KINGSTON FOSSIL PLANT (KIF) - ANNUAL ASH POND DIKE STABILITY INSPECTION

ANNUAL ASH POND DIKE
STABILITY INSPECTION

Prepared by: John G. Albright
Jeff L. Gray
Date: February 24, 2004

Photo 3. Ripraps put on toe of the slope to stabilize it.

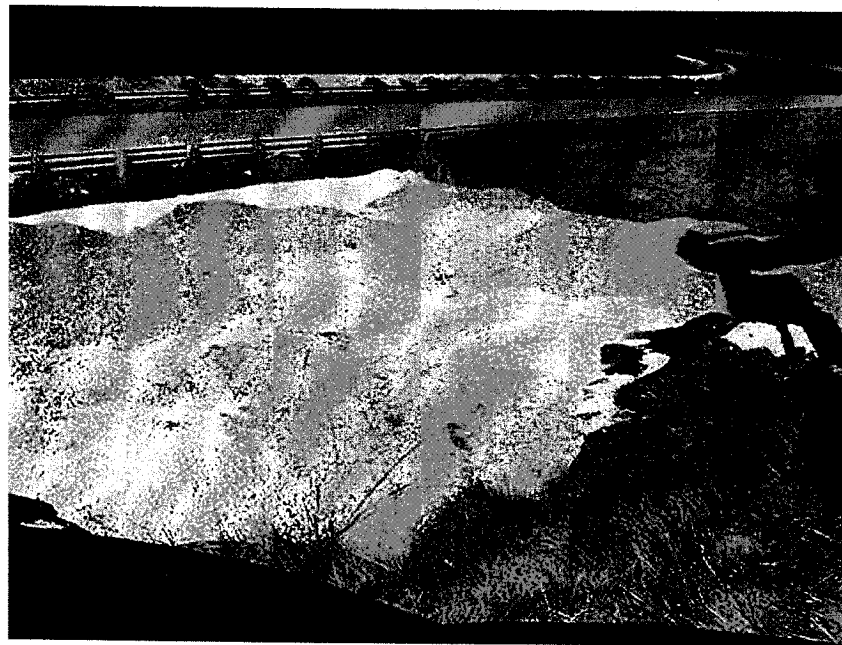
The top of the dikes elevation is 811 feet. A leak occurred at the toe of the slope on the east side slope of dredge cells 2/3 on November 6, 2003 (Photos 1 and 2). Dredging operations were ceased immediately. Yard Operations personnel began draining dredge cells 2/3. Cell 1 had already been drained. On November 7, 2003 plant personnel with instruction from EDS Civil Engineering (see attached e-mail) began efforts to try to stabilize the leak area. Over 100 tons of riprap was placed on the toe of the slope to help stabilize it (Photo 3). The next day ash and water was observed seeping from the dike approximately 10 feet further up the slope. A filter fabric was placed over the seepage area and twenty feet beyond each side of it. Approximately twelve inches of crush stone was then put on top of the fabric (Photo 4). EDS Civil Engineering and its design partner MACTEC are trying to determine the cause of the leak, the best method of repairing the dike, an alternate location for a new dredge cell if needed and if/when dredging operations can resume.

A berm was constructed in the drainage ditch at the toe of the dike slope for dredge cells 2/3 to prevent ash leaking from the dredge cell from getting into the river. Water is pumped from the ditch into the Ash Pond. Several check dams were constructed in the drainage ditch beyond the berm to catch sediment. Sediment fences and bales of hay were also placed in the drainage ditch (Photo 12). Water observed in the drainage ditch adjacent to the bales of hay on the day of the dike inspection appeared to be clear. None of the cells were being dredged into at the time of inspection. Dike slopes with sparse vegetation should continue to be reseeded and mulched until a good vegetative cover is apparent (Photo 13). Add top soil to the slope of the upper lift so a vegetative cover can be established to help control erosion.

I talked to Jeff again this morning. Nothing appears to have changed overnight; that's a good sign. The recommended repair, initially, is to place significant quantities of rip-rap in the ditch to begin the stabilization. Then, add crusher run stone as a "filter blanket", a layer of filter fabric, another layer of crusher run and finally cover the area with more rip-rap.

The crusher run is both a filter for the ash and protection for the fabric. All of the rock weights the toe so it will not slide out into the road. The crusher run layers need to be 4 - 6" thick and the rip-rap should be 3 feet thick on top and as much as needed on the bottom to get up to the original ditch bottom or a little higher. The top layer of rip-rap should be extended back to the dike slope and the top kept level. The top layer of rip-rap will likely be above the road elevation. The repair should extend 50 feet in both directions from the "blowout" to ensure another one does not happen.

Photo 7. Ash Pond Discharge Diffusers

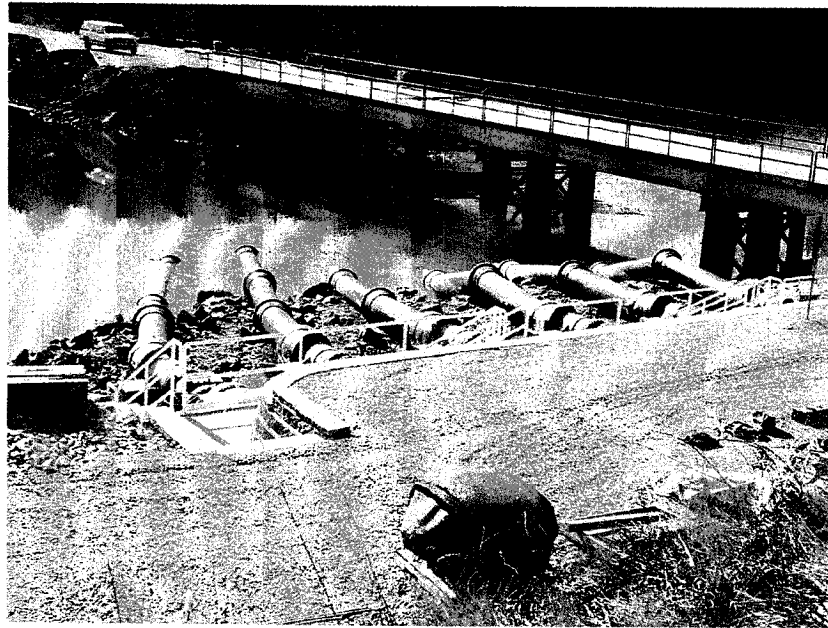
The sluice water flows into the stilling pool through two plant constructed spillways. From the stilling pool, the water discharges into the plant intake channel via six standard spillways. Construction on new discharge diffusers was completed November 2003. At the time of the inspection, five of the six discharge diffusers were operating (Photos 6 and 7).

Photo 10. Road ruts. Note slopes needs mowing.

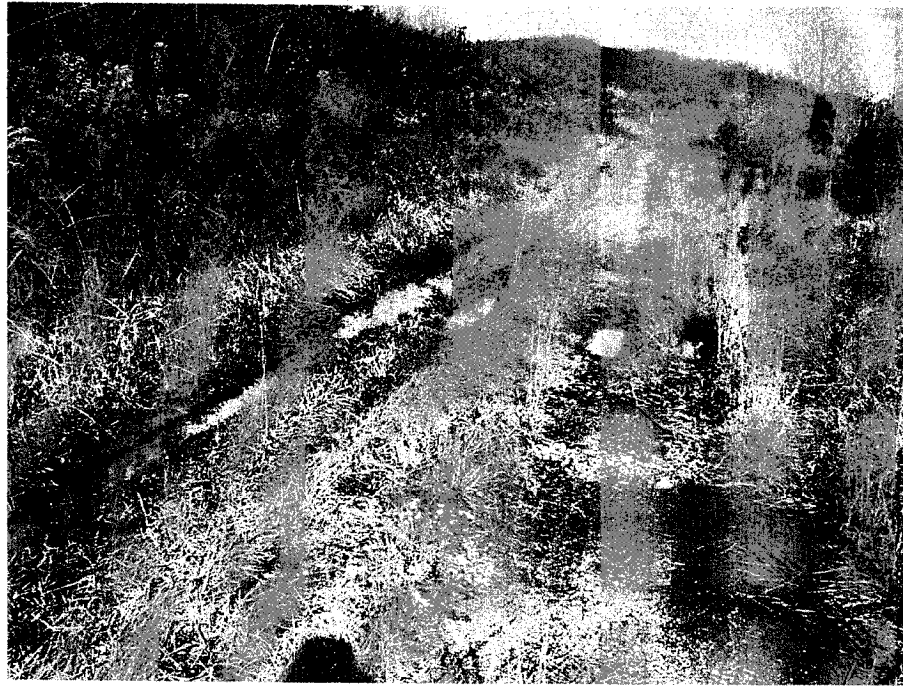
All dike roads were in good condition with a good ash or crushed stone surface except the lower dike road along the East side of the pond (Dike C) and the South Stilling Pond lower dike. Several areas of the roads were rutted and held water (over 12 inches deep in some places) making vehicle passage impossible (Photos 10 and 11). These areas should be repaired as soon as possible. The dike slope near one of the road ruts showed signs of erosion (Photo 9). This area should be repaired as soon as possible.

- Repair the ruts in the road along the stilling pool and Dike C by filling with soil, compacting it, grading the road to turn water to the outside and covering the repairs with ¾" crushed stone. It is estimated the repairs will require approximately 20 yards of soil to fill the ruts and 70 tons of stone for cover.

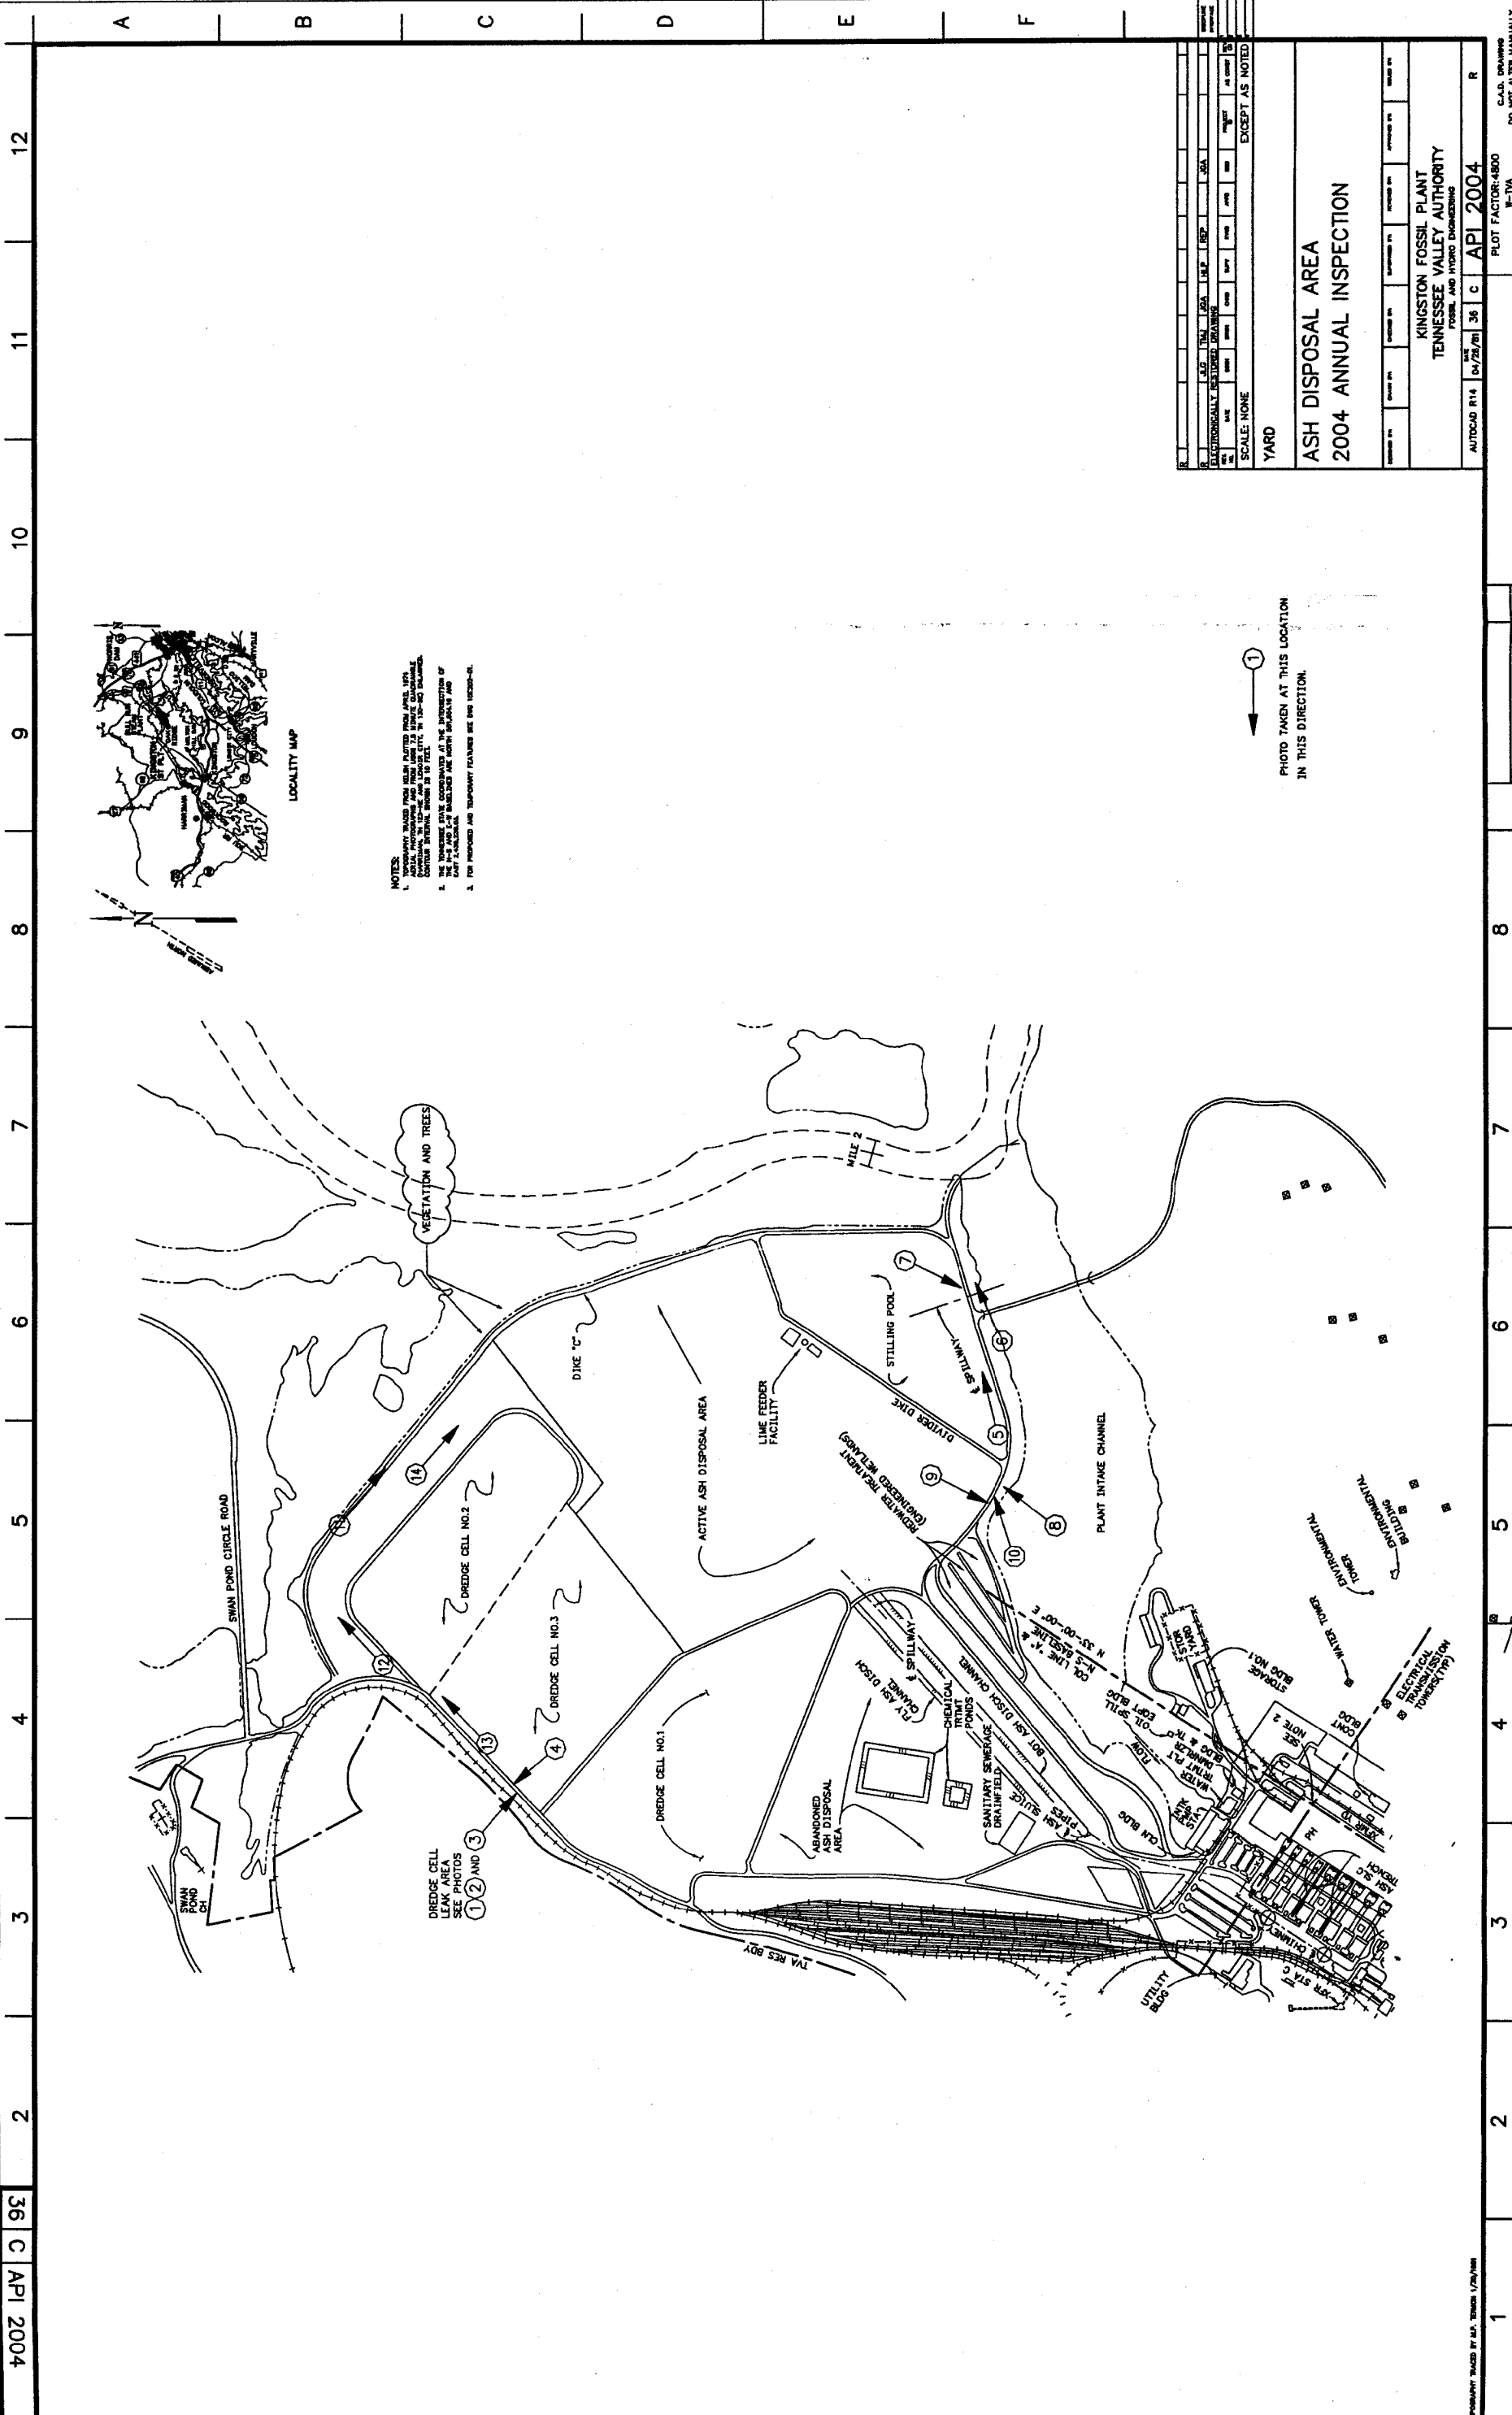
The coal yard drainage basin is located at the southwest corner of the coal pile. This basin was excavated below grade; therefore, there are no exterior dikes (Photo15). The interior slopes appeared to be in satisfactory condition. Normal discharge from this basin is pumped into the fly ash discharge ditch and flows to the active ash disposal area. At the time of inspection, water in the pond was at a low level, about 6" below the first pump start switch and the platform was grounded. The basin was sounded at 4 places and found to have a depth of 1.08 feet average when the water was at elevation 751. This indicates the sediment in the bottom occupies 4.92 feet of the basin's storage capacity. This represents a 1.67 feet increase in sediment depth since the last inspection. The basin was dredged just over two year ago, we recommend dredging the basin annually. The bottom of the pond should be no higher than elevation 745. Elevation 745 allows 2 feet of clearance below the pump intakes to prevent the pumps from pumping solids; the elevations indicate the pumps have been pumping solids for some time. In addition, the "V-shaped" pond extensions added during the summer of 2001 to increase the pond storage volume contained coal yard sediment (Photo16). TVA drawing 10W225-1 shows the pond and its intended bottom contours.

- Dredge the Coal Yard Drainage Basin to restore its design contours and protect the pumps from further damage. There is an estimated 2,800 cubic yards of sediment in the original pond and an extra 3,400 cubic yards in the "V" section that needs to be removed as soon as reasonable. See the attached copy of 10W225-1.
